ADDENDUM NO. 1
Amelia River Waterfront Stabilization Parking Lots C & D
City of Fernandina Beach
Invitation to Bid # 21-06
Issued: May 25, 2021

III. Changes to Drawings: (See attached)

Drawing name: F:\PASSERO\FHB\99000047.0095 FHB Waterfront\Airport\C5-01-PROF_XSCT.dwg C6-3_XSCT by: EBredestege May 25, 2021 5:56am

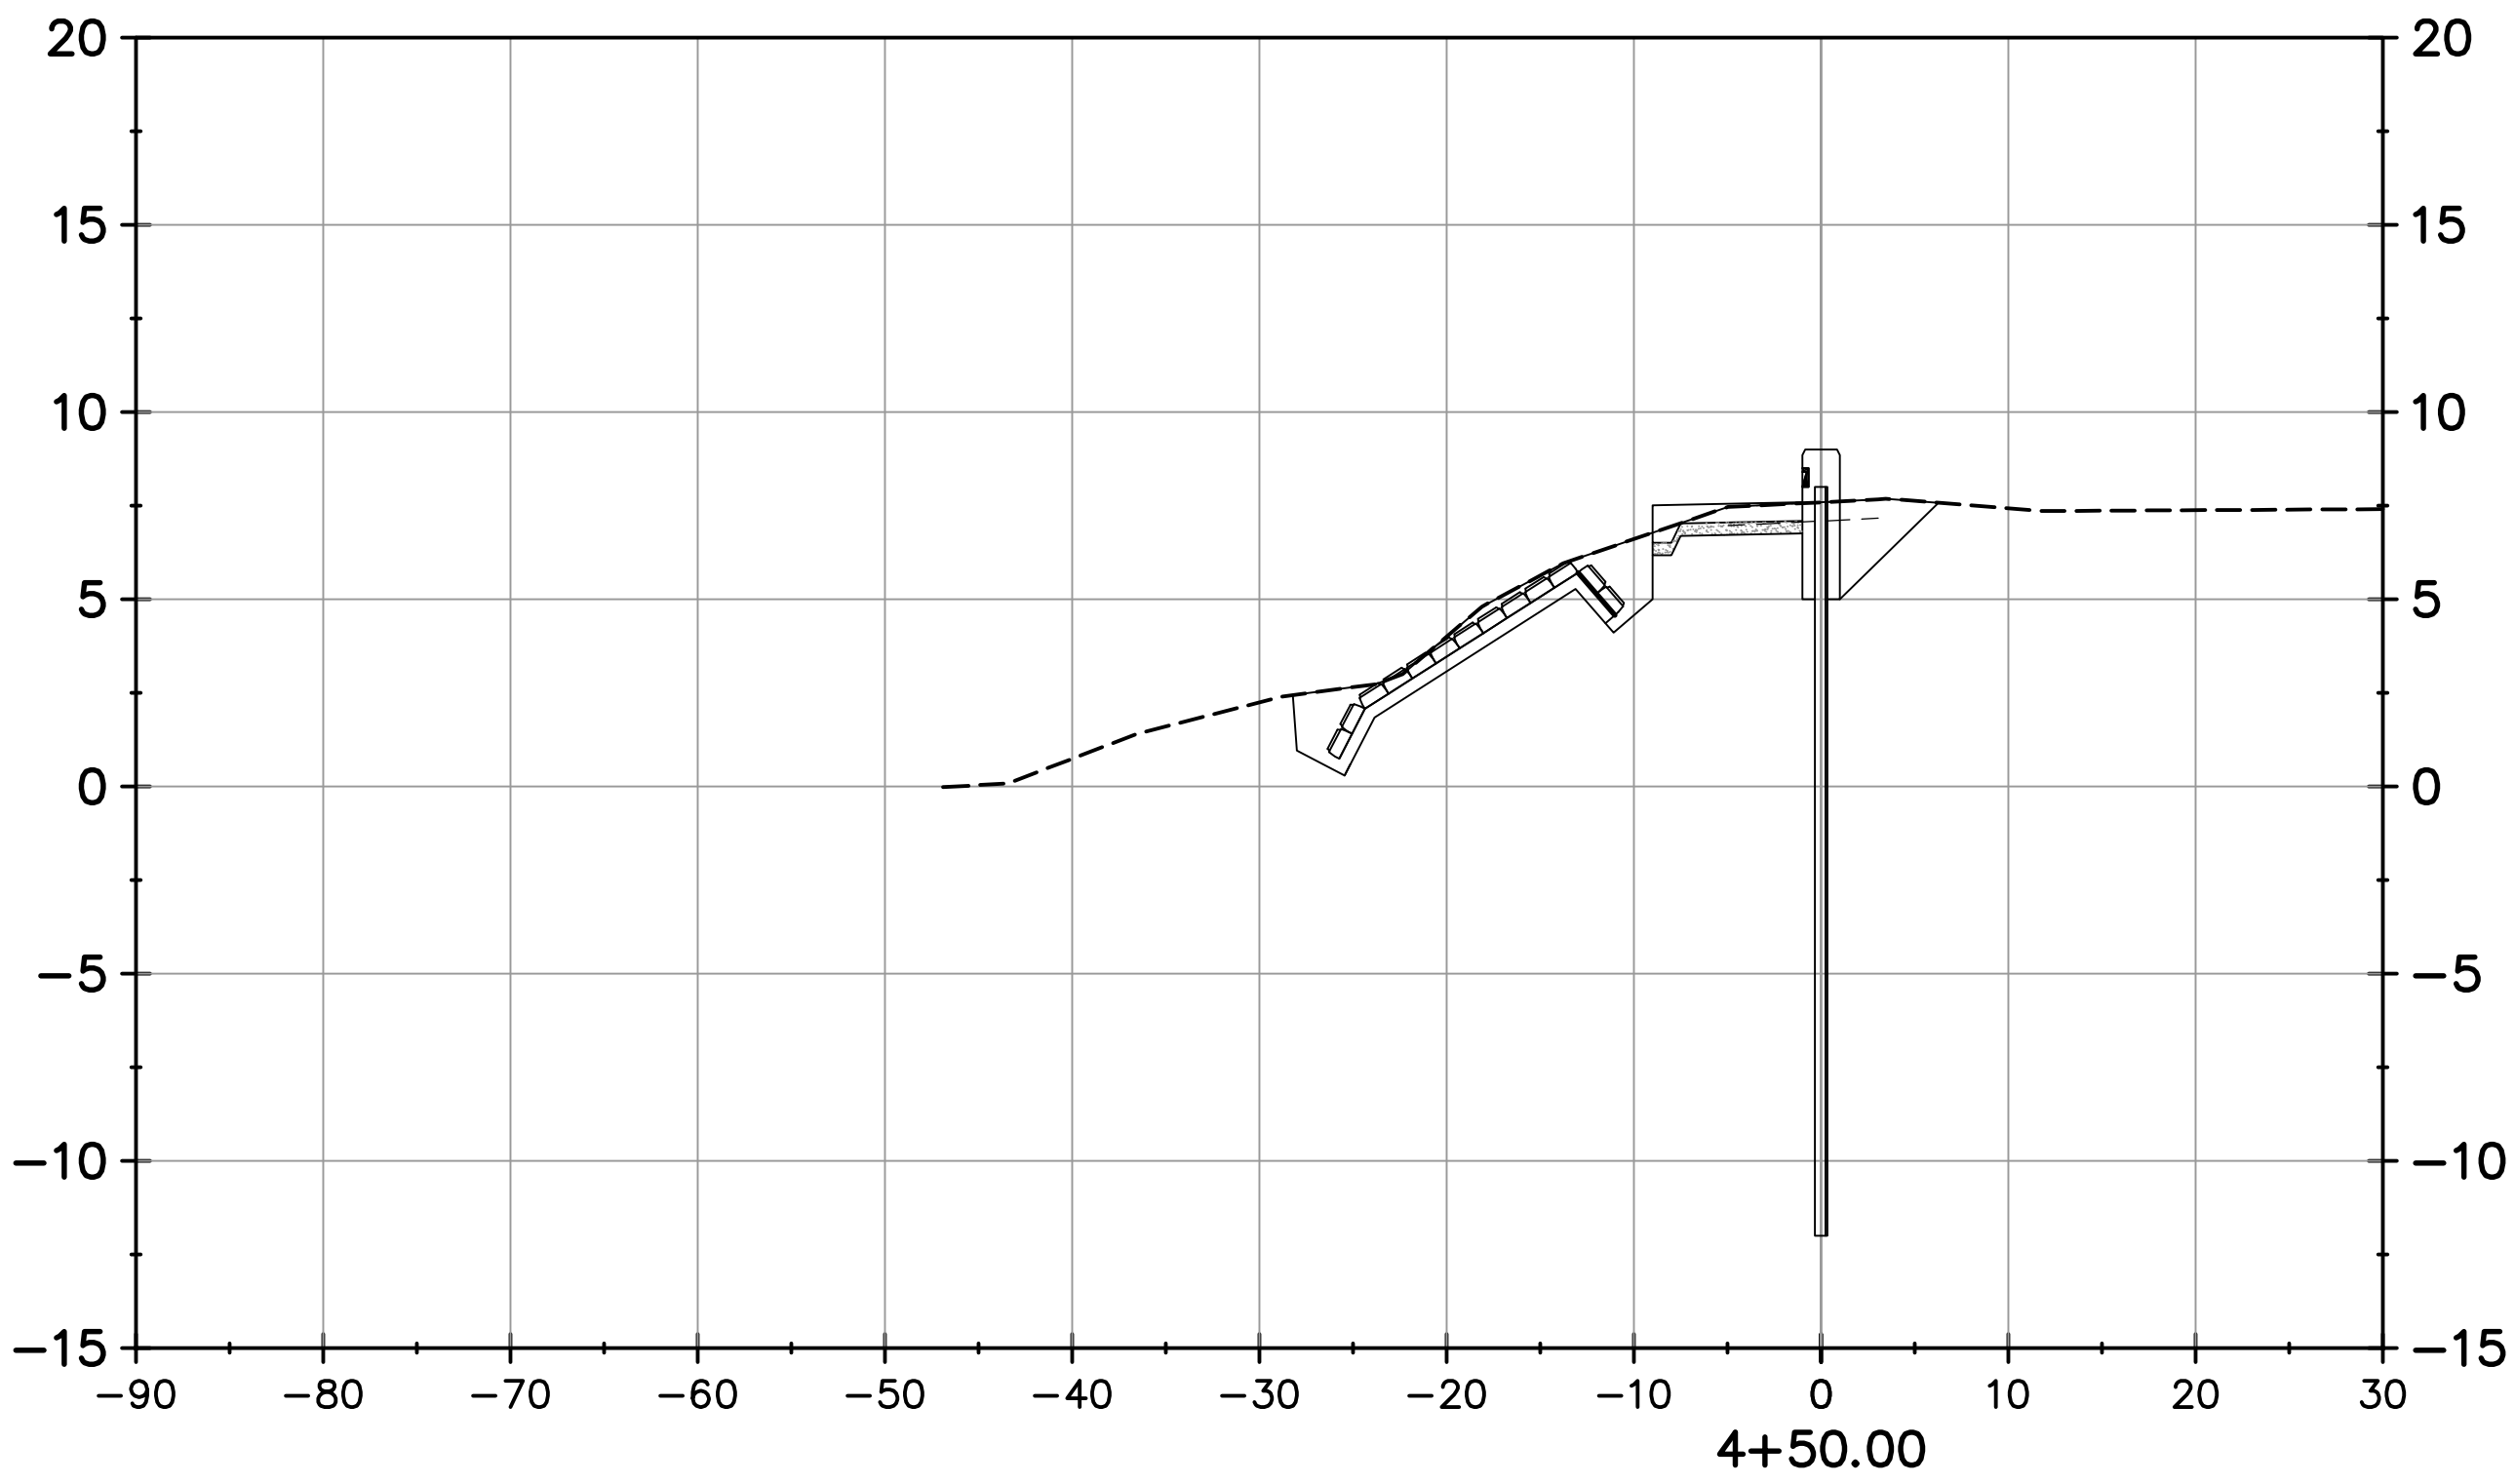
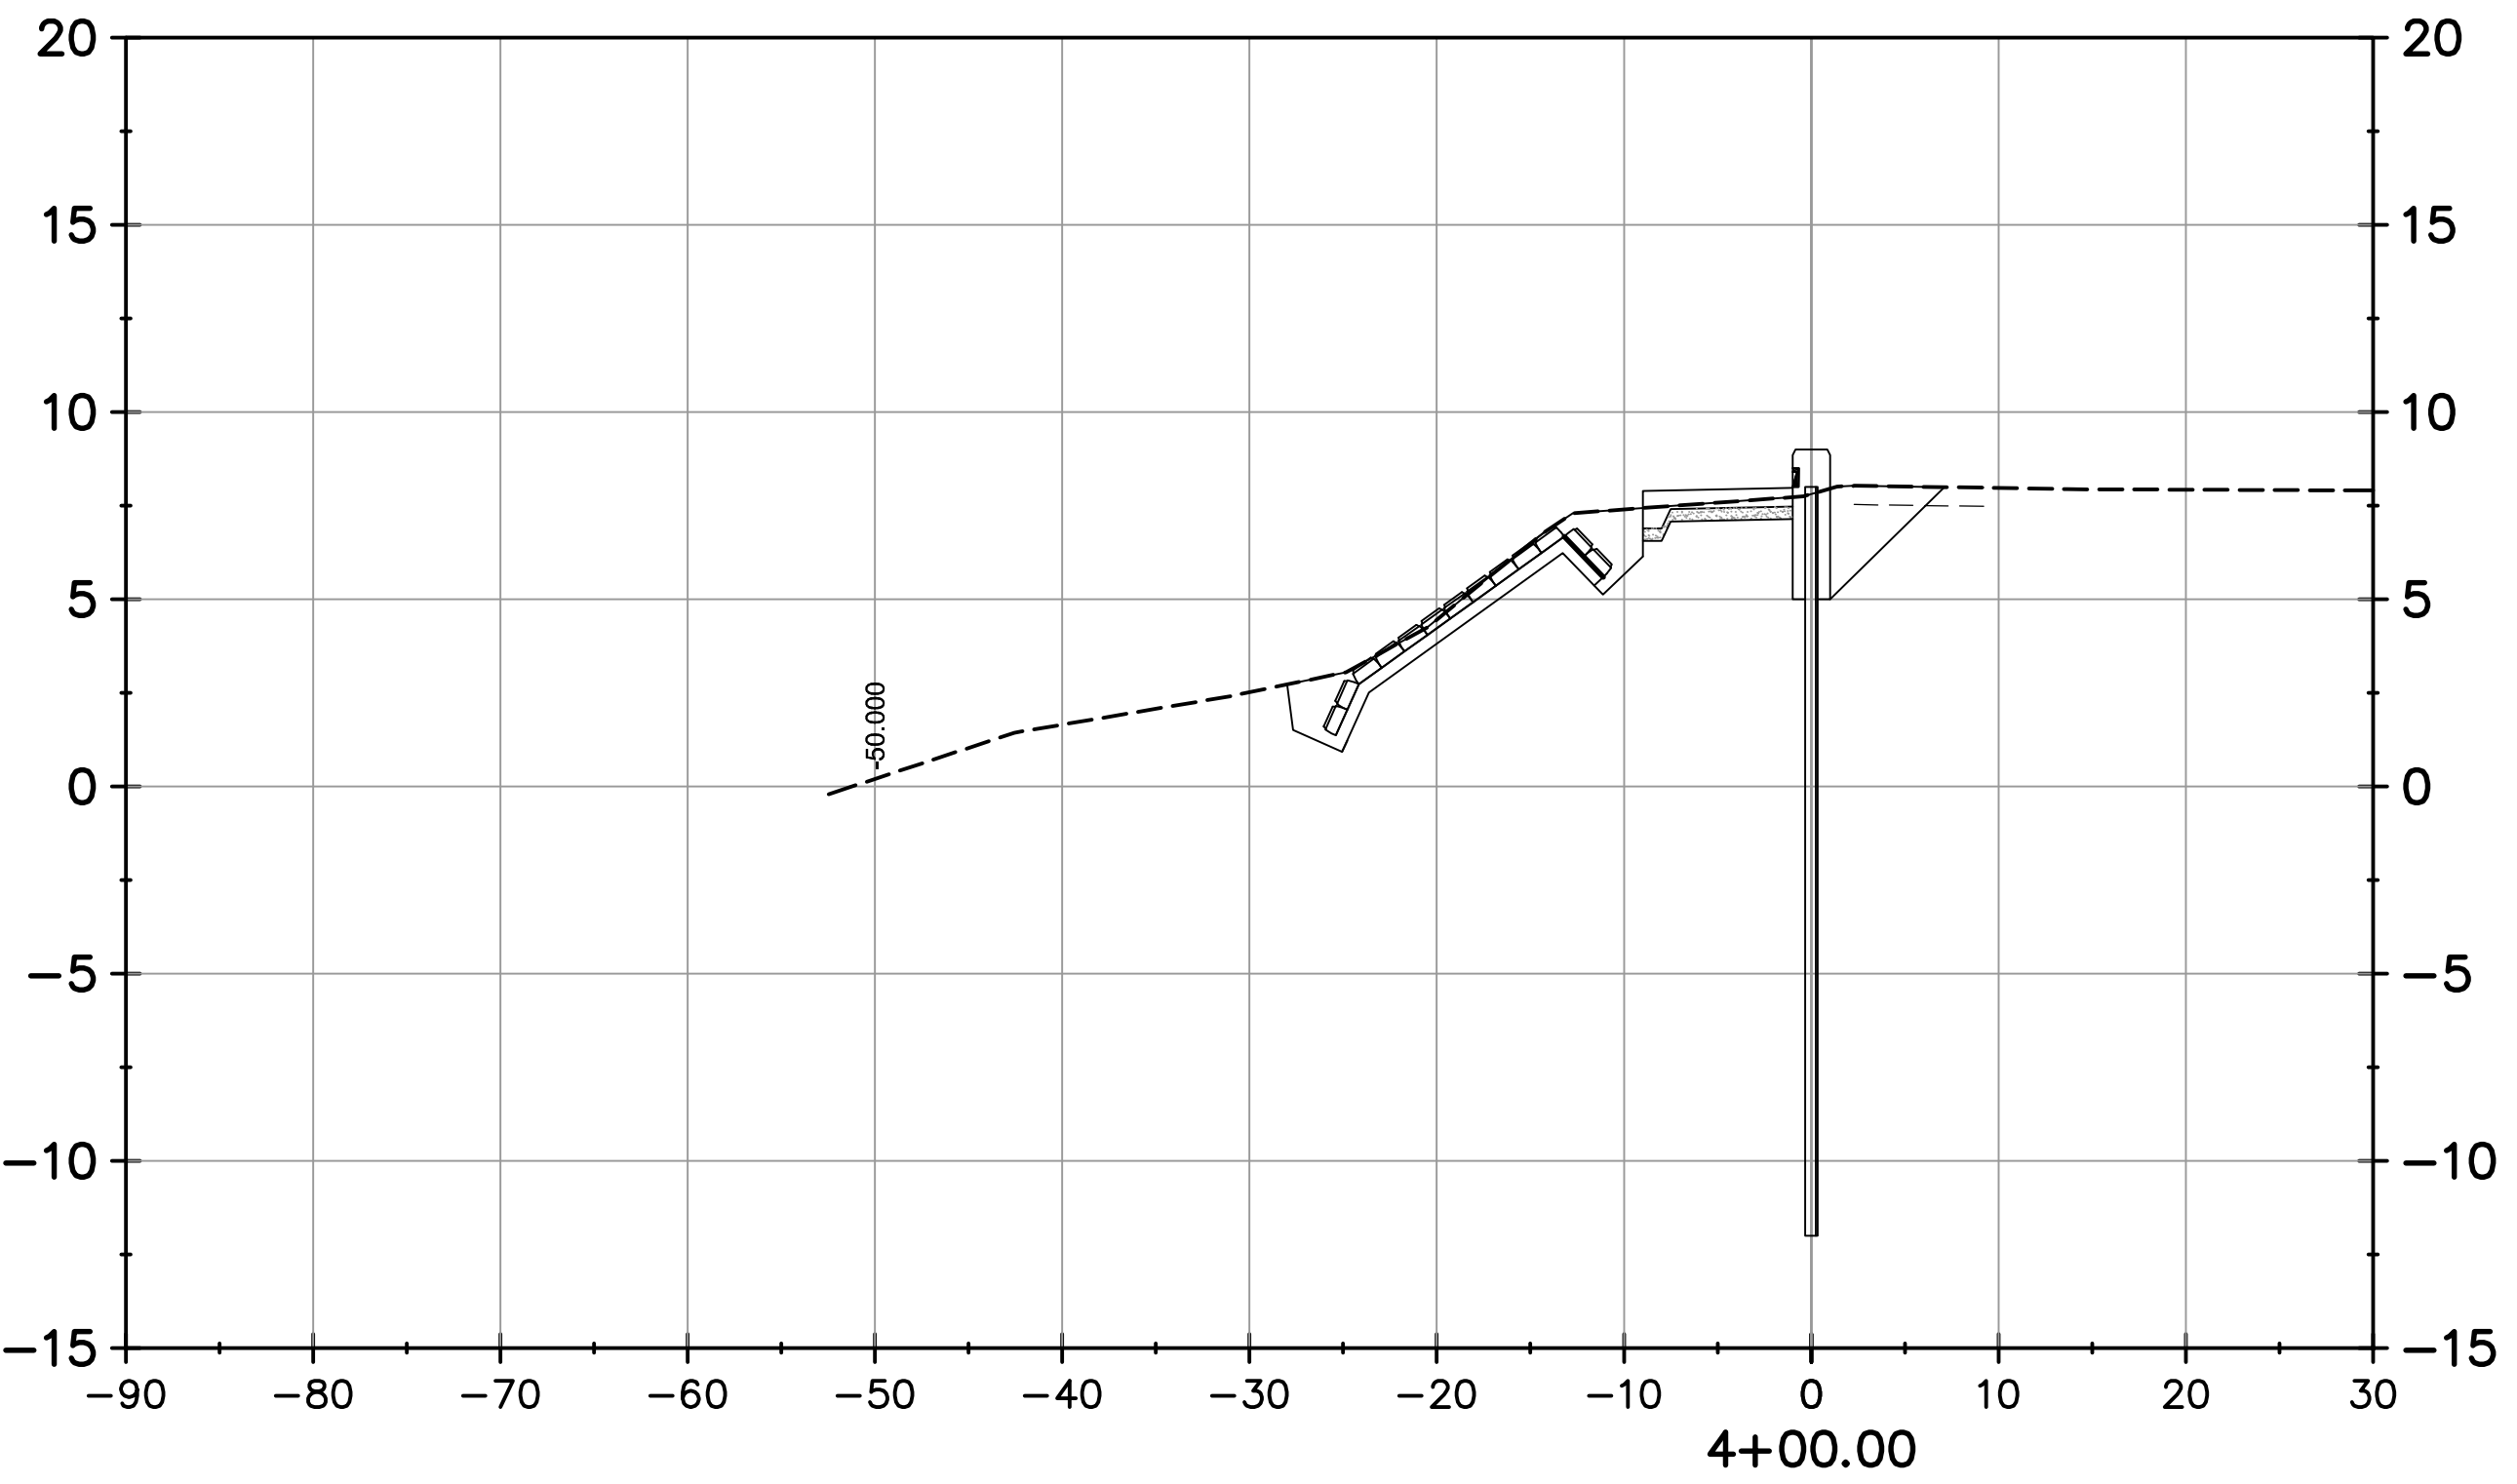
- 22) Sheet C6-3 - Revised I-Wall & Boardwalk Alignment and Cross Sections Adjusted.
- 23) Sheet C6-4 - Revised I-Wall & Boardwalk Alignment and Cross Sections Adjusted.
